BBC
BROWN BOVERI

Subject: BBC Brown Boveri
HK Control Device

Subject BELLEFONTE NUCLEAR STATION
A.O. 33-51014 & 33-54753

IB-8303

FIG. 1

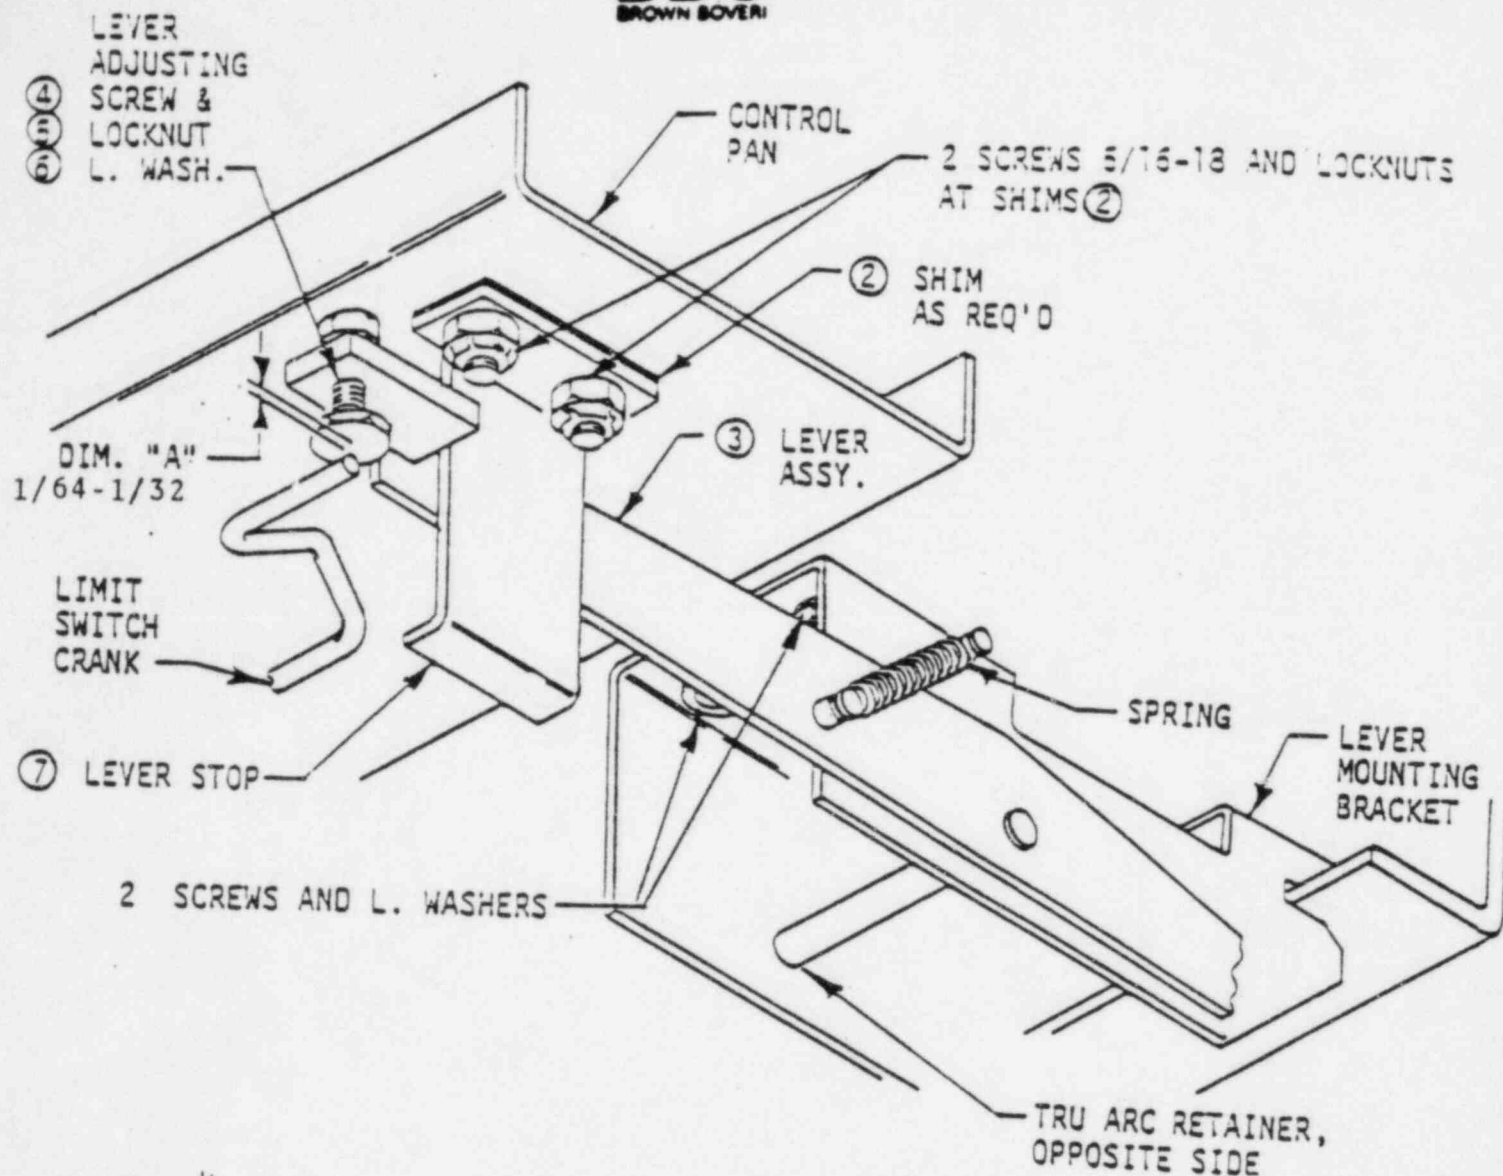
2. INSPECTION AND ADJUSTMENT FOR DIM. "A" (See Fig. 1)

- 2.1 Charge the closing springs electrically or manually.
- 2.2 Check Dim. "A" with feeler or pin gages.
- 2.3 If required, readjust the screw (4) to Dim. "A" after first loosening the jam nut (5) and then retightening the jam nut after the adjustment.
- 2.4 Close and open the breaker to discharge the closing springs.

FIG. 2

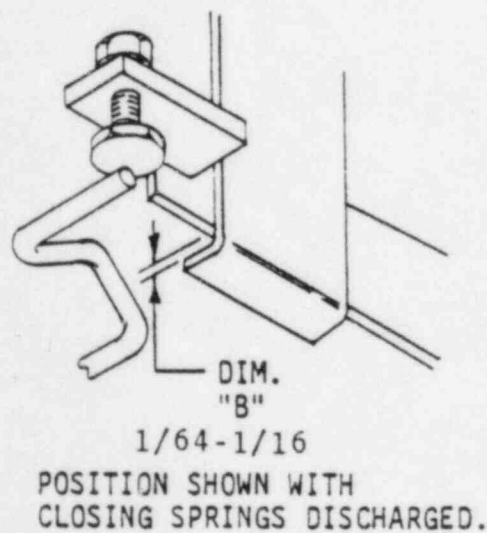
3. INSPECTION AND ADJUSTMENT FOR DIM. "B" (See Fig's 1 and 2)

- 3.1 For this procedure, the breaker is to be open and the closing springs discharged.
- 3.2 Check Dim. "B" with feeler or pin gages. (See Fig. 2)
- 3.3 If Dim. "B" is not within dimensions, it is necessary to shim the lever stop(7) up or down as required. This is done by adding or removing shims(2) at the lever stop. (See Fig. 1) Note that if all shims are removed and the Dim."B" still exceeds the max. allowed, the length of the lever stop should be checked. The lever stops made after July 1978 are $2 \frac{17}{32}$ long. Previous to this, the length was $2 \frac{25}{32}$. If required, install the shorter lever stop (7).

<u>Qty. Per Breaker</u>	<u>Notes</u>
2. Shim 650451-A27	As req'd (3 est.)	
7. Lever stop 193392-A	1	2 17/32 overall length. Used in breakers built after July 1978.
